Case No. 2025-00177
Barrelhead Solar, LLC
Response to Siting Board's Second Request for Information

Siting Board 2-1:

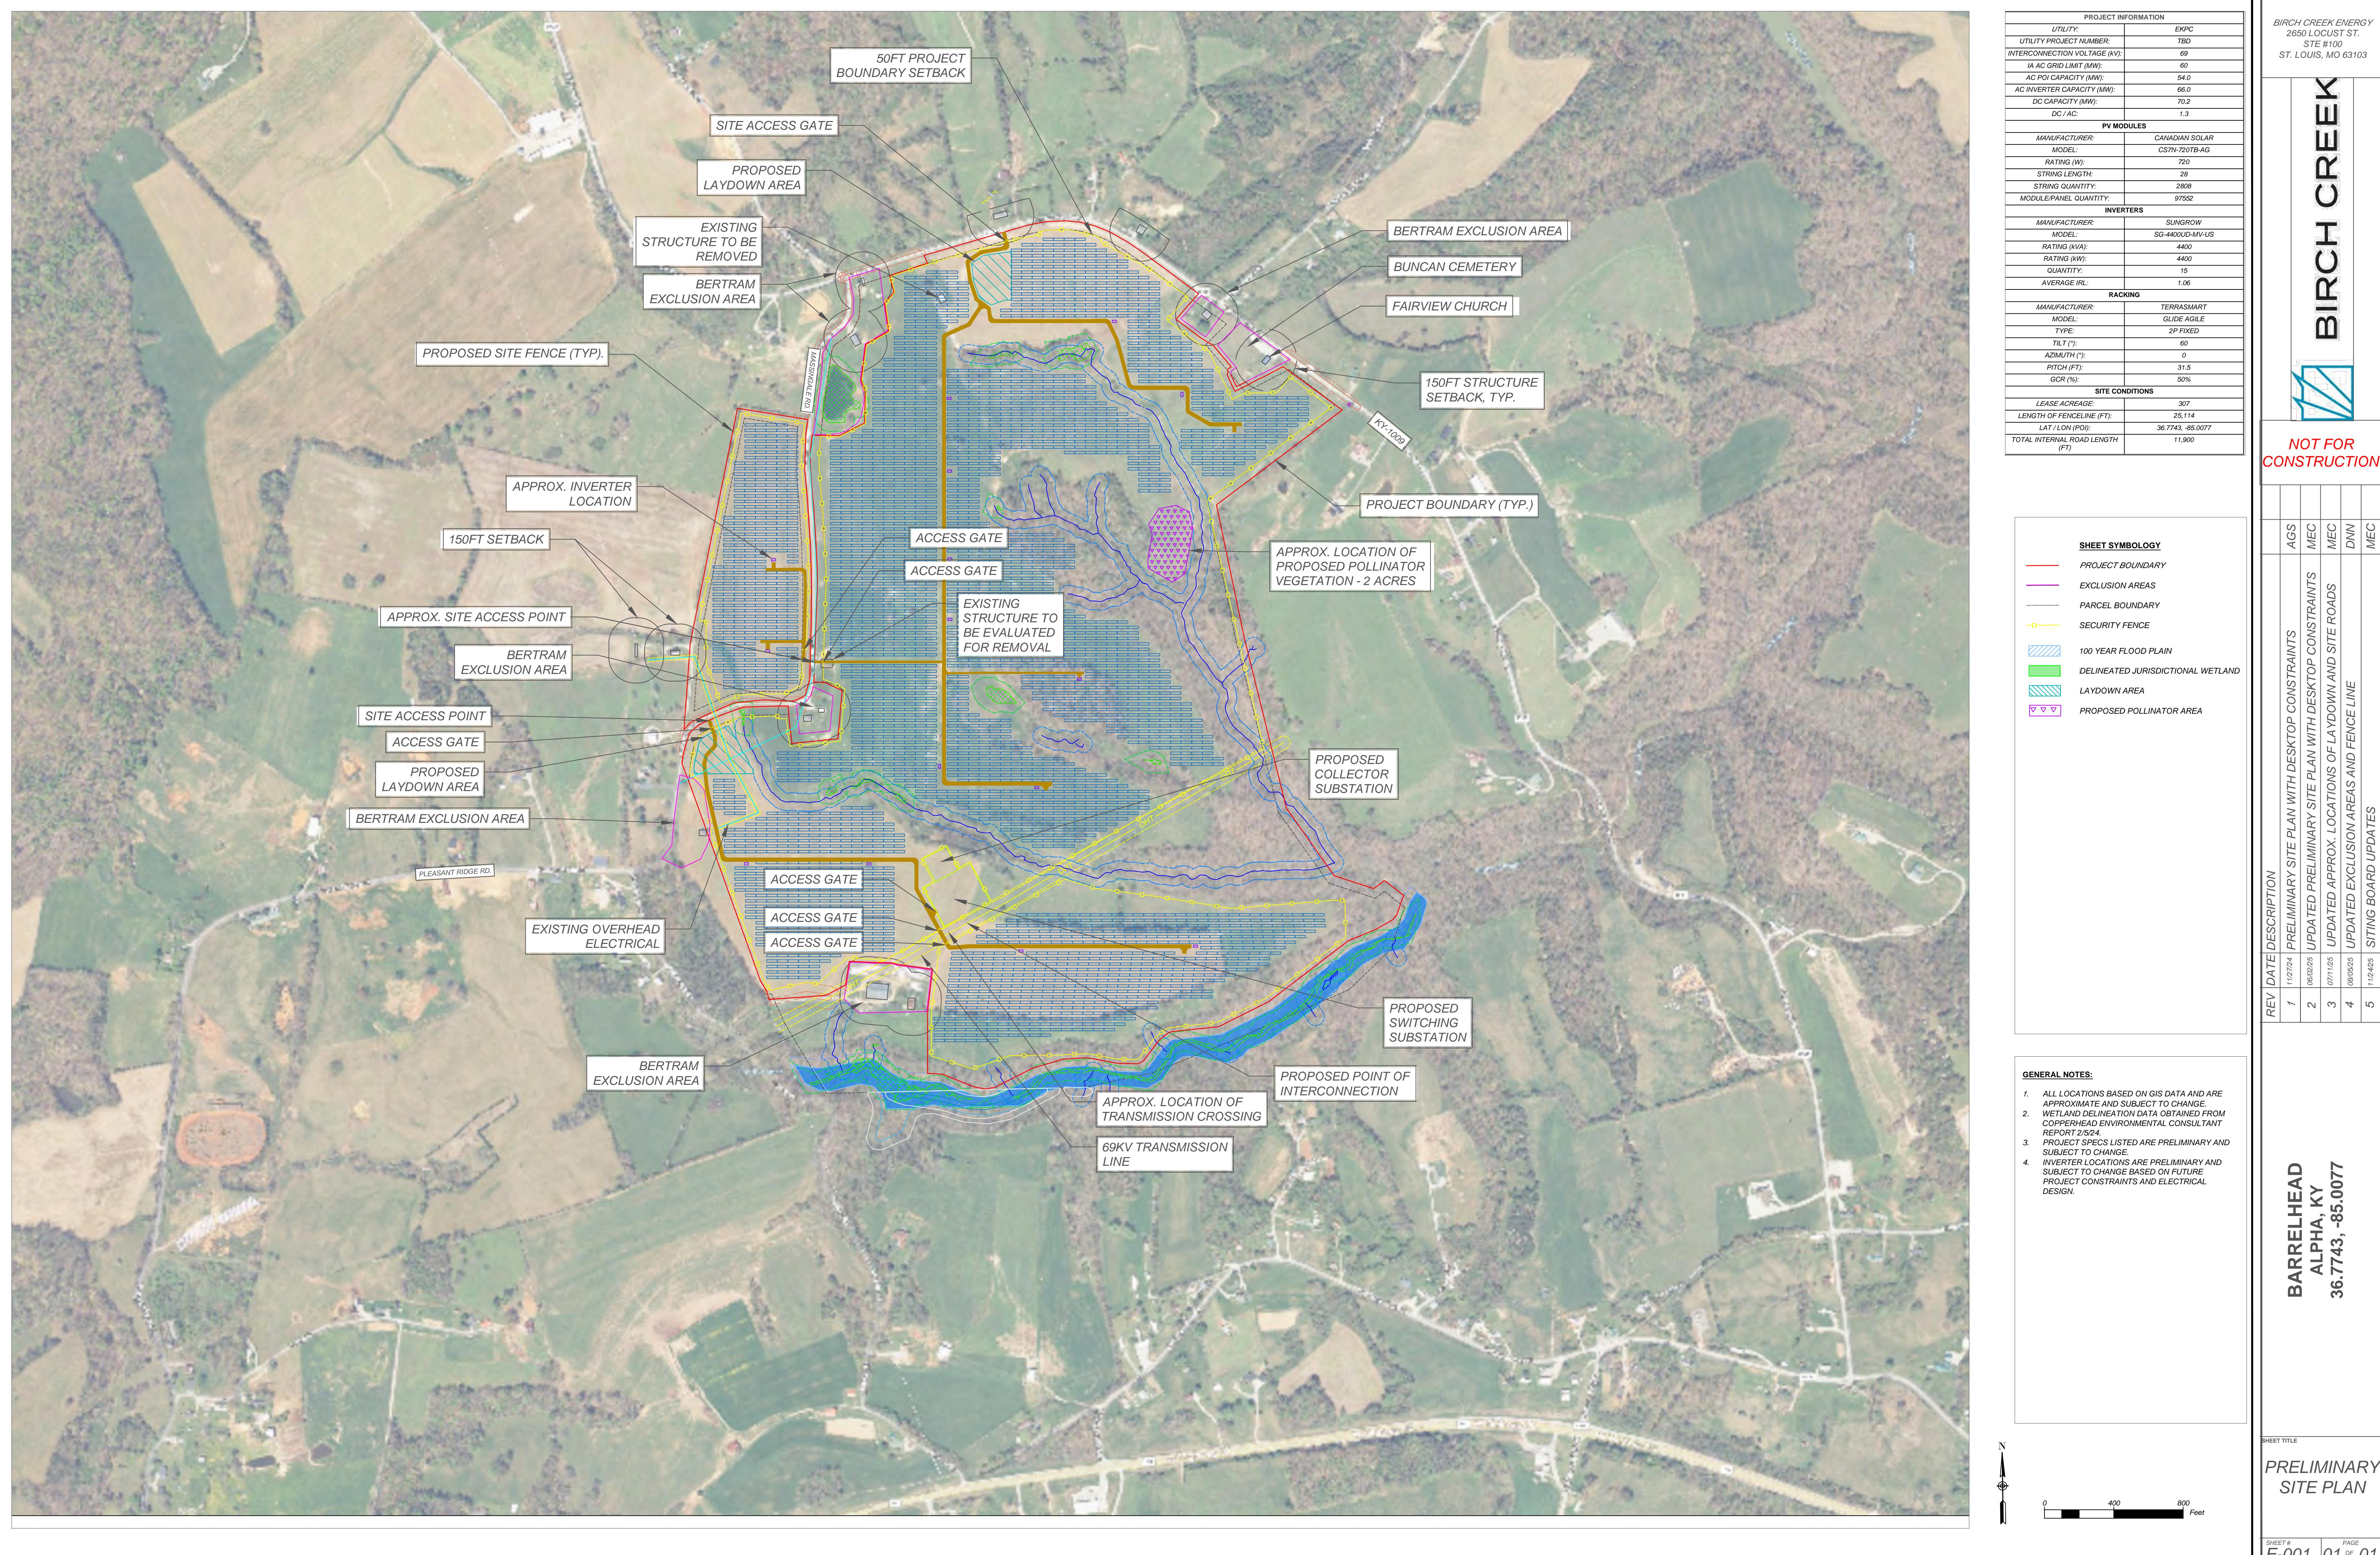
Refer to Barrelhead Solar's response to Siting Board Staff's First Request for Information (Staff's First Request), Item, 49. During the site visit, it was confirmed that R-15 is a non-participating residence requiring a structure setback. The Applicant additionally noted that the proposed access road route near the southern laydown area was cut-off. Provide a revised preliminary site layout with corrections.

Response: A revised preliminary site layout is provided as Attachment 2-4.

Figure 1. Overview of surrounding roadways and proposed entrances to the Project Area.

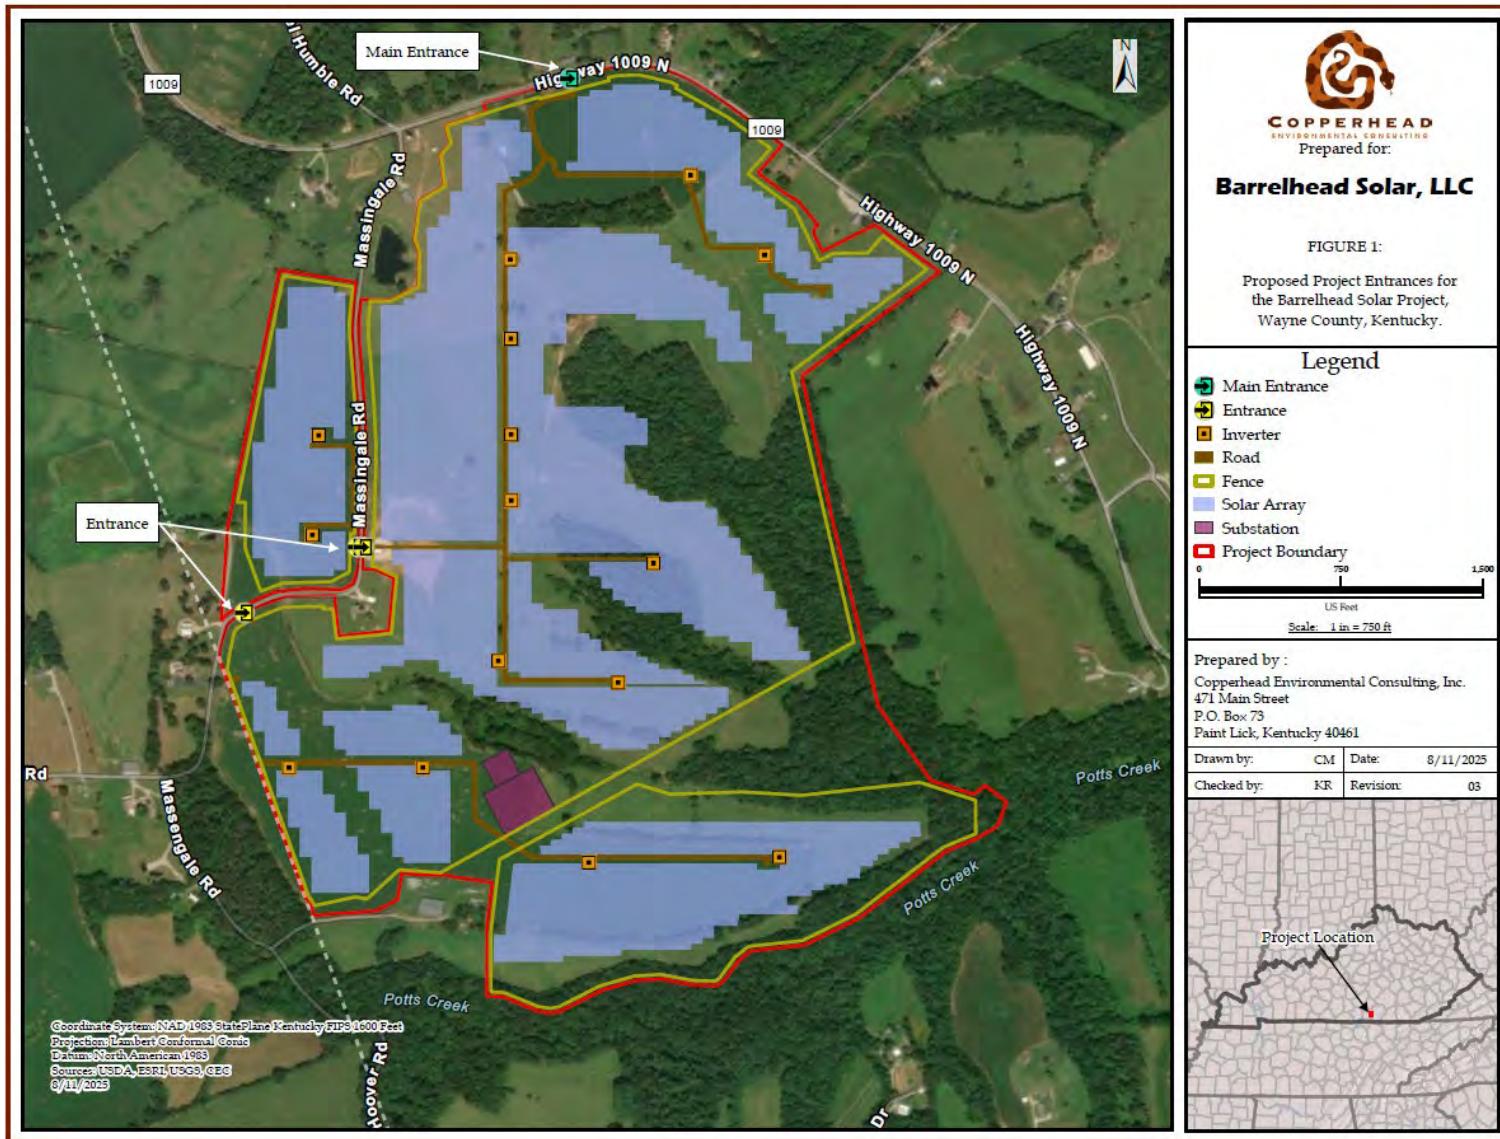
Refer to SAR Appendix I, Traffic Impact Study. During the site visit, it was confirmed that Pleasant Ridge Road will likely be utilized for Project deliveries, including the substation transformer. Provide a revised Traffic Impact Study inclusive of Pleasant Ridge Road.

Response: A revised Traffic Impact Study that includes information about Pleasant Ridge Road is provided as Attachment 2-14. As explained in RFI No. 2-13, once selected, the EPC contractor will determine haul routes and coordinate with either or both Wayne and Clinton County Road Departments.

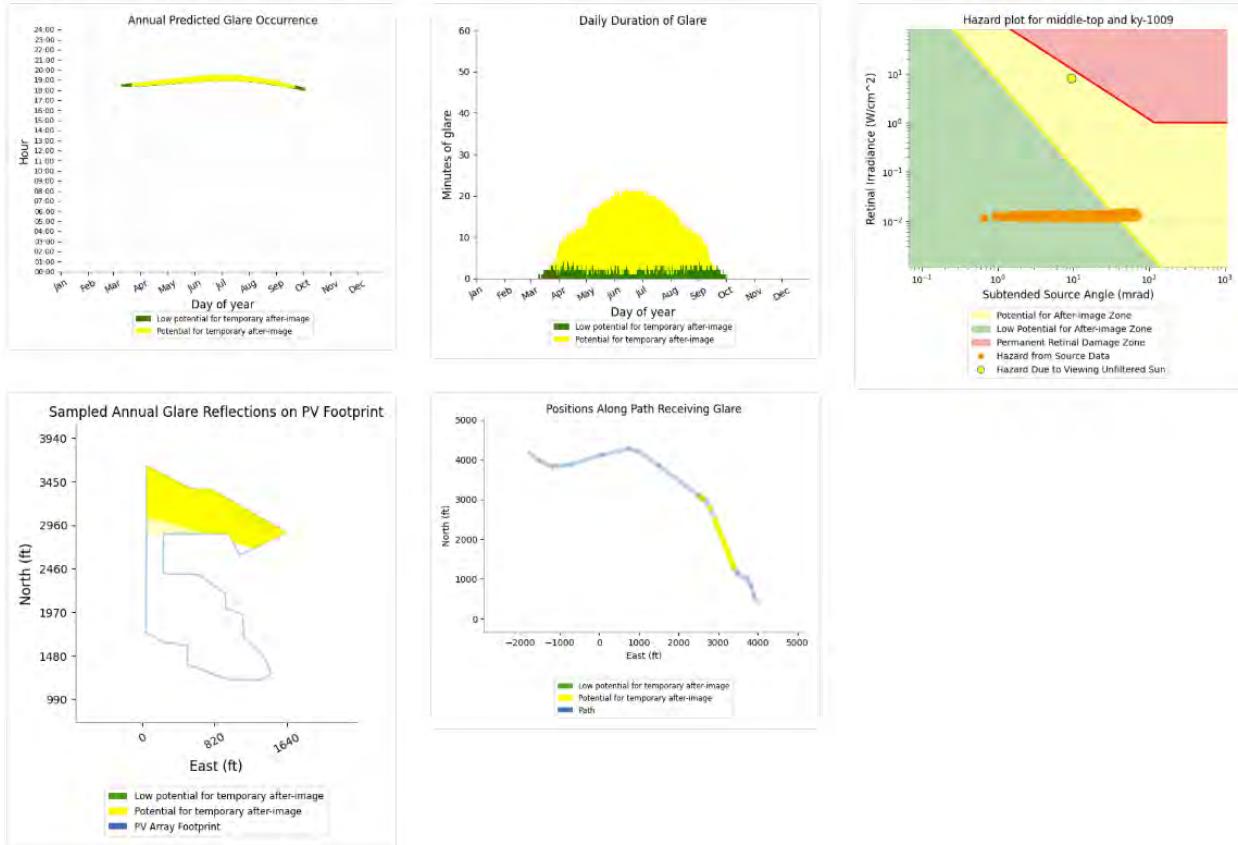
Refer to the SAR, Appendix G, Glare Analysis. Refer to Table 2 and Table 6 for a comparison of modeled results for KY 1009. Explain whether Table 6 indicates that yellow glare would be experienced along KY 1009 over a longer period of time (March through September) using the tracking arrays, as compared to the fixed arrays (March and September), from the middle top panels.

Response: That is correct, the anticipated duration that yellow glare could be experienced on KY 1009 from the Middle Top section using tracking arrays is from March to September. See ForgeSolar results graphic, below. Also see Attachment 2-54 for ForgeSolar results of both fixed and tracking analyses.
